Planning Decisions Committee

6.30pm, Wednesday 20 January 2021

1. This report provides Council with an assessment of planning permit application PLN20/0037 which is for the construction of a six-storey building, with a reduction in the car parking requirements associated with the use of the land as a food and drink premises (cafe) and as-of-right office at Nos. 25 Balmain Street & 128 - 134 Cubitt Street Cremorne & Laneway TP938653J Cremorne VIC 3121. The report recommends approval of the application, subject to conditions.

S57 Plans: Balmain Street Frontage (Jackson Clements Burrows Architects October 2020)

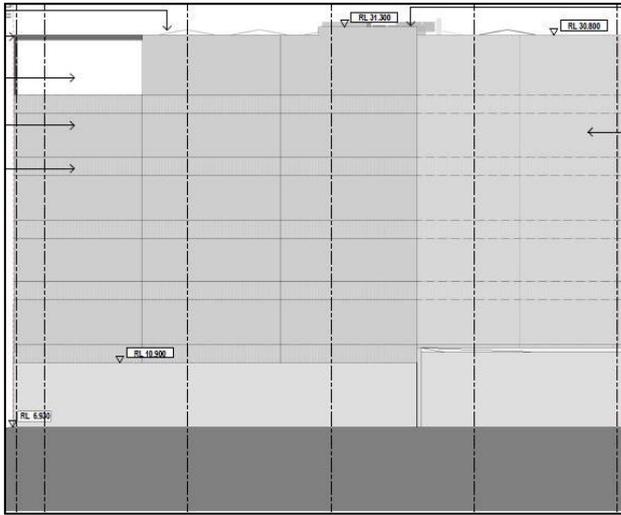
118. Based on the advertised plans, Council’s Urban Design Unit found the ratio between blank wall/services area and glazing at ground floor unacceptable. Therefore, in order to provide a more active street frontage, the applicant revised the ground floor treatment as part of the S57A submission; with the extent of glazing along Balmain Street increased compared to the advertised plans (see image below showing the comparison highlighted in pink and blue).

Advertised Plans: Northern Façade (Jackson Clements Burrows Architects June 2020)

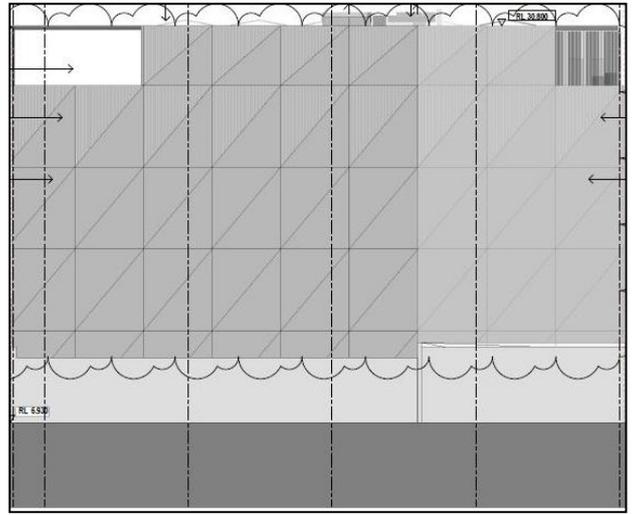
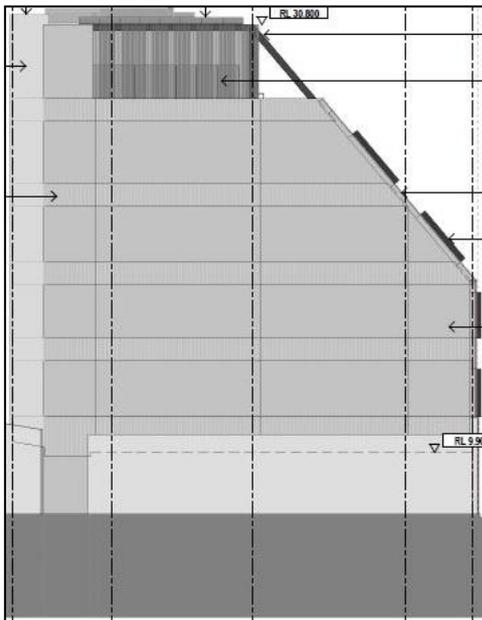
127. Council's Urban Design Unit found *the large expanses of blank wall along north and west facades will make the form appear more bulky from street views*. Whilst such material treatment has been proposed in order to ensure equitable development opportunities of adjacent sites, Council's Urban Design Unit recommended that *till those sites are developed these walls will be very visible from the surrounding areas and therefore, to provide some level of articulation or design or texture on these blank walls so the development does not detract from the fine grain character of the streetscape when viewed from oblique views*.

128. As a result, under the S57A submission, the applicant altered the previously proposed horizontally applied patterned and ribbed concrete to a diagonally patterned mix of concrete and ribbed concrete to the northern and western facades (see images below). This is an important feature of the design as it will reduce visual bulk impacts to nearby properties but also because it will ensure that the side boundary walls (which will be highly visible from the public realm) are aesthetically integrated with the development's overall architectural composition.
